TB 136

TECHNICAL BULLETIN

Product : Midilift XL+

Subject : Lifts with Diagonal Braces (Shaft by Others).

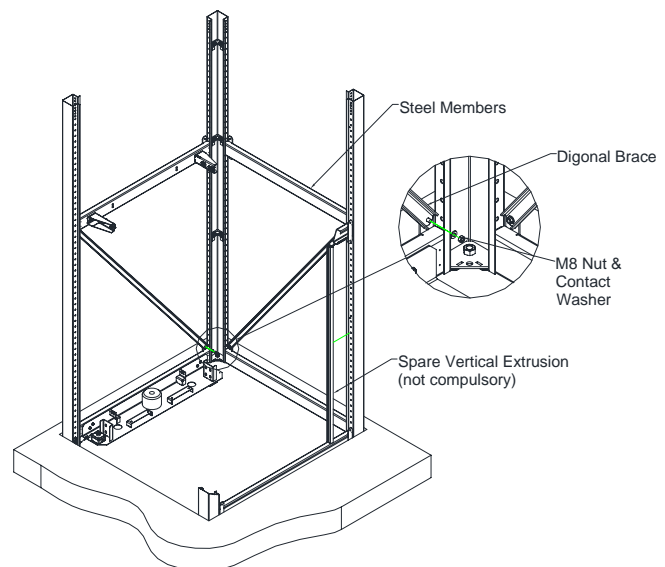
An option has been introduced to remove infill panels on lifts sited within a lift shaft provided by the builder. In these instances the panels, on the sides of the lift structure which do not have an entrance, will be replaced by diagonal braces.

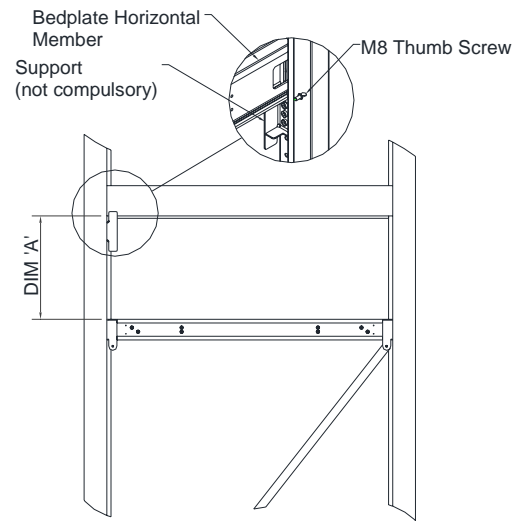
Diagonal braces are bolted to the lugs as shown.

The bedplate horizontal member should be installed to the dimension shown on the builder's work drawing.

Note: A support is available to take the weight of this member while the fixings are inserted, although this is not compulsory. The support can be positioned in increments of 25mm, but is removed to achieve the final dimension shown.

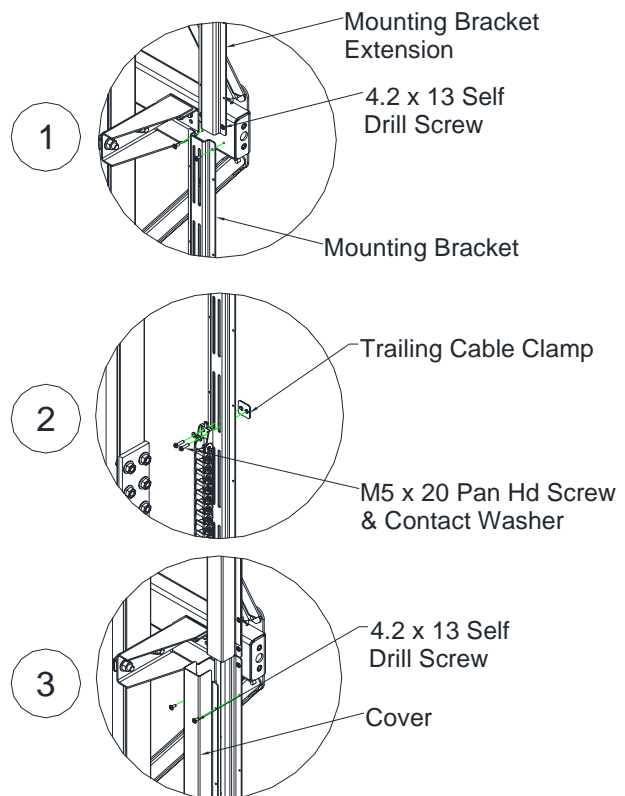
The cable chain is secured to a mounting bracket which spans two horizontal members. This should be positioned to mount the end of the cable chain at a position of half the travel plus 200mm above the pit floor.

Extension brackets should be mounted above this to the horizontal member just above where the cables will enter the control box.

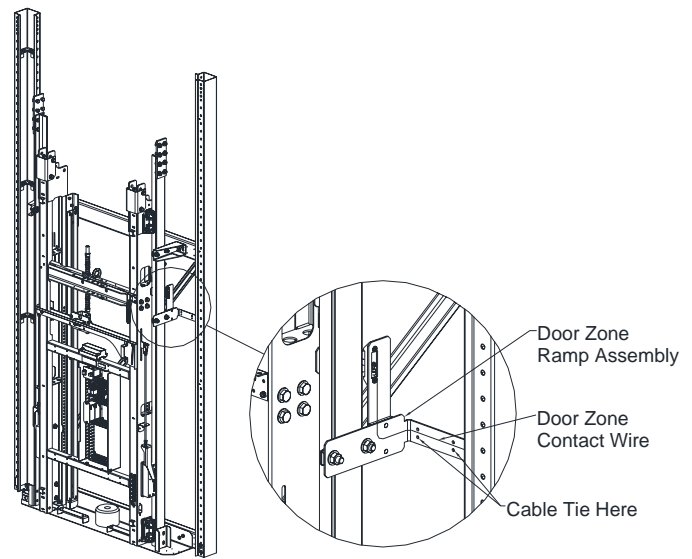
Trailing cable covers are secured to the mounting and extension brackets. The upper & lower covers should be cut to length to suit.
